No.	EIR/FSS Section(s)	HRCA Issue/Comment	Category	Responsibility (HRCA/MMM)	Response
					soils which will not be conducive to mitigating infiltration. We do not agree that the potential exists for greater infiltration on the site that the water balance predicts. The water balance is based on clay-rich soils (predominantly Soil Type D (~80%), with some Soil Type D (~20%)). The water balance predictions of monthly base flows in the watercourses were identified in the report to be in close agreement with flows measured at the watercourses within the site. Additional investigative techniques such as percolation testing would be carried out during detailed design in the areas where infiltration measures, such as infiltration swales, are specifically proposed along the periphery of the natural environment areas. As noted in the report and in the response above, site grading activities (cut and fill) over much of the developable land area will leave large areas of the site with exposed soils that are not conducive to effective mitigative measures using infiltration.

37	Section 6.3.1.1	Meander Belt Width, Page 6-2 & Appendix 6.7 - Reach 14W-12A is not included within Table 1 within Appe

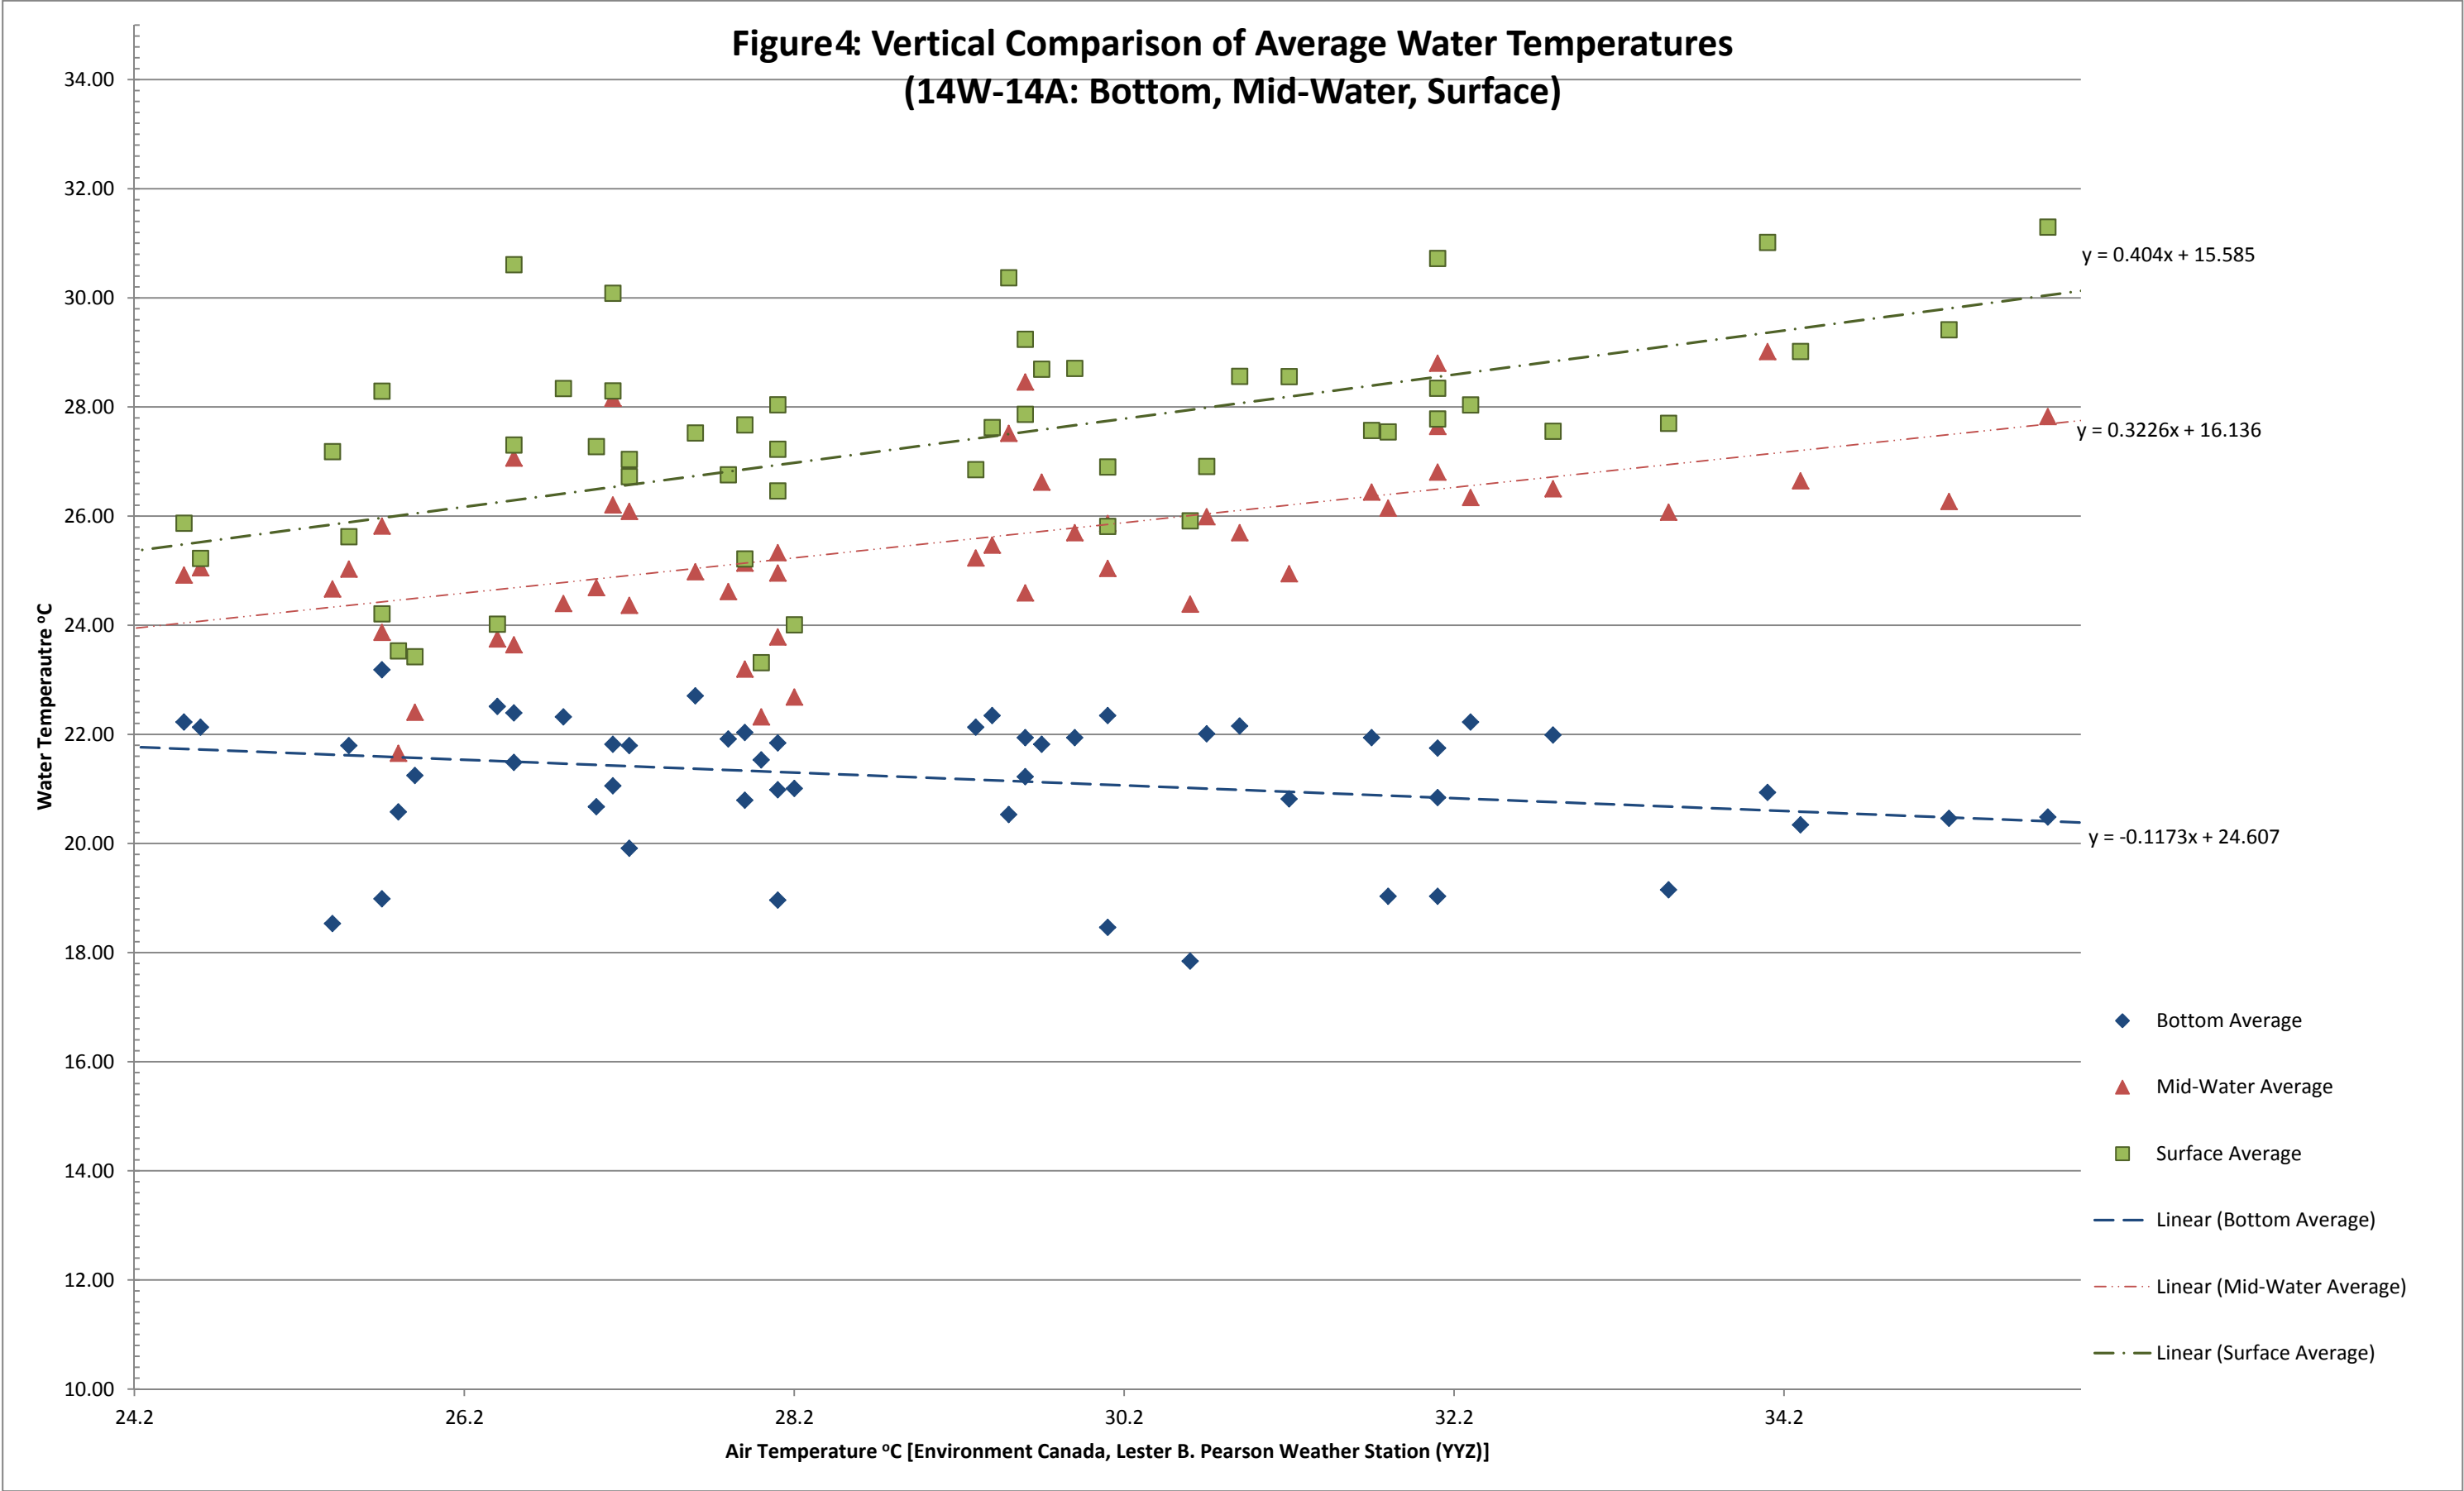
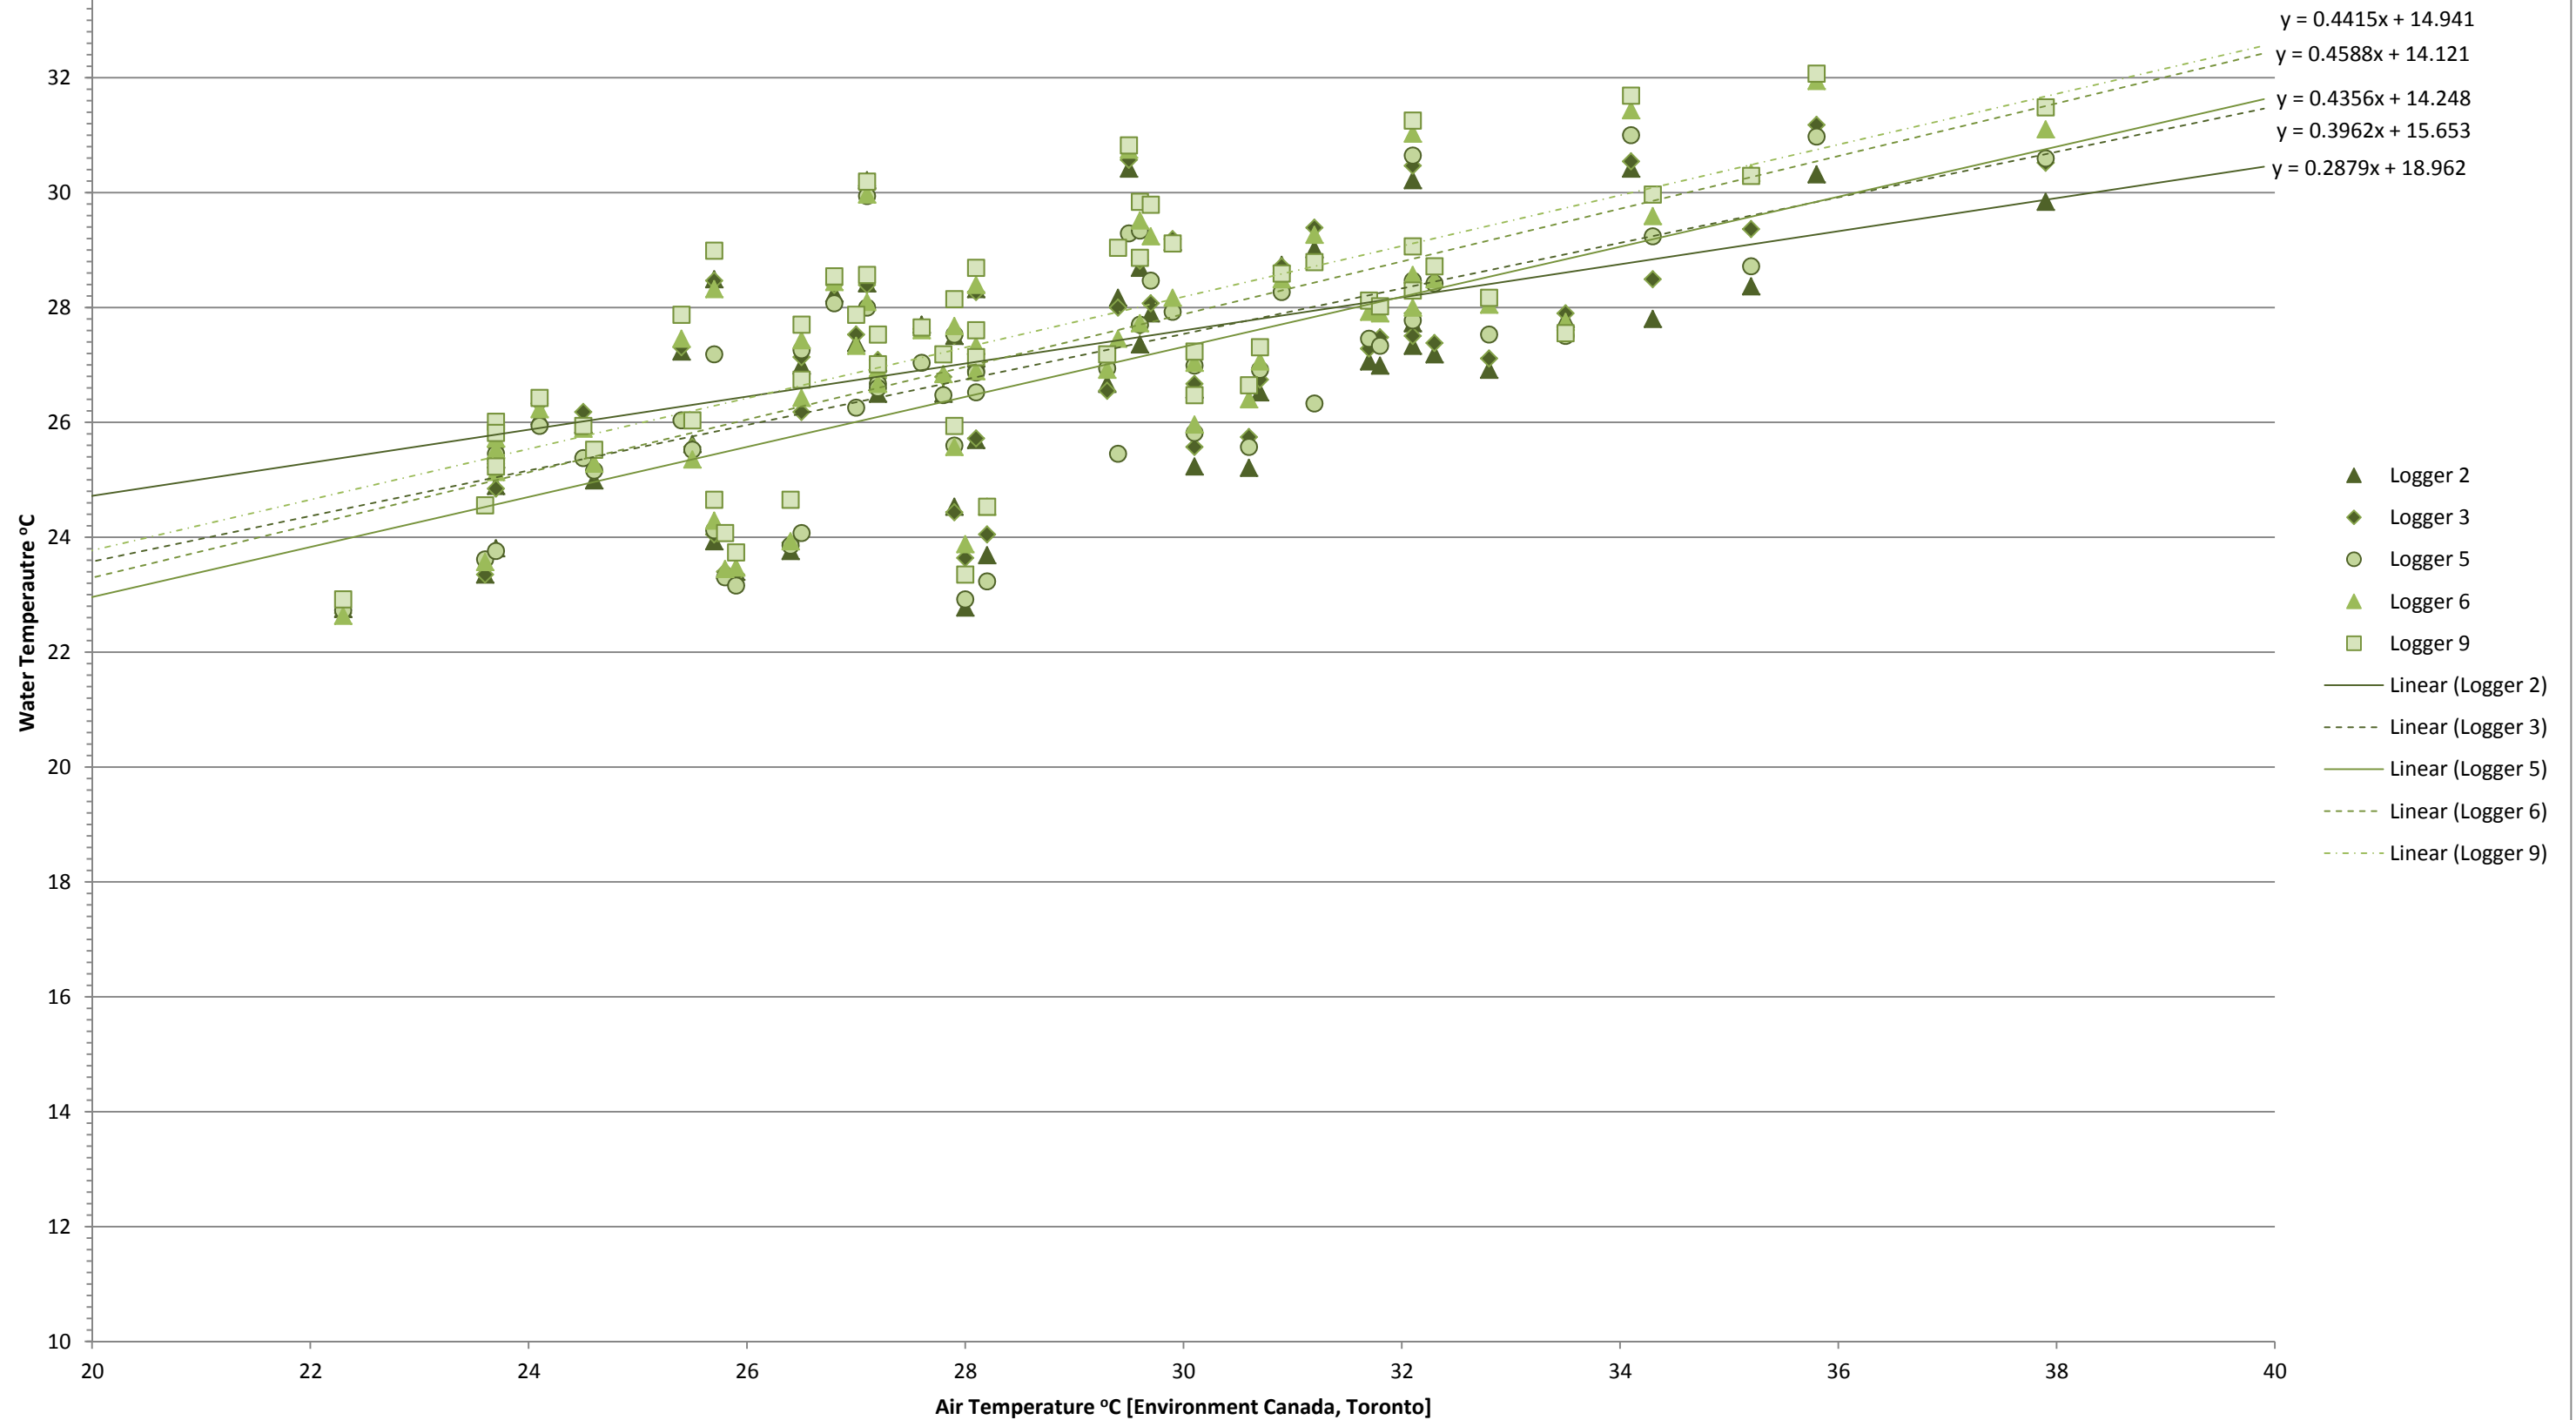
64	Appendix 5.6	Water Temperature Monitoring Data - Comment not addressed to the satisfaction of CH Staff because the STATE analysis was not applied to the temperature data graph.	2	MC	Following numerous attempts to unsuccessfully use the STATE analysis software that was requested by CH we contacted the developer of the software for direction. The developer stated that error/crashing experienced by MMM staff was due to the sample size being shorter than 6 months and they have yet to resolve this issue.

No.	EIR/FSS Section(s)	HRCA Issue/Comment	Category	Responsibility (HRCA/MMM)	Response
					As you are aware CH requested in their August 5, 2011 email that water temperature data collection in the farm pond with specific reference to water temperature data collection be initiated as soon as possible to include the month of August and extend to September 15th. This information was relayed by CH in advance of the email in a voicemail message from L. Smith in June and as a result the loggers were in place by June 30, 2011. Although the recording period collected data through the summer months and beyond, it was not sufficient to capture the required timeframe to allow the STATE analysis to work. Furthermore, an analysis of the water temperature was undertaken using 3 other acceptable methods. Water temperature data was initially assessed using the methods in the <i>Ontario Stream Assessment Protocol (OSAP) (Stanfield, 2005)</i> and <i>A Thermal Habitat Classification for Lower Michigan Rivers (Wehrly et al, 1999)</i>. The general results were presented to CH during a site meeting and CH requested the assessment of the data using the <i>Evaluation of a Simple Method to Classify the Thermal Characteristics of Streams Using a Nomogram of Daily maximum Air and Water Temperature (Cindy Chu, et. al., 2009)</i>. This third tool was also used to assess the water temperature data. All three methods yielded relatively consistent results and were presented in the EIR. Given the limitations of the STATE analysis tool, the
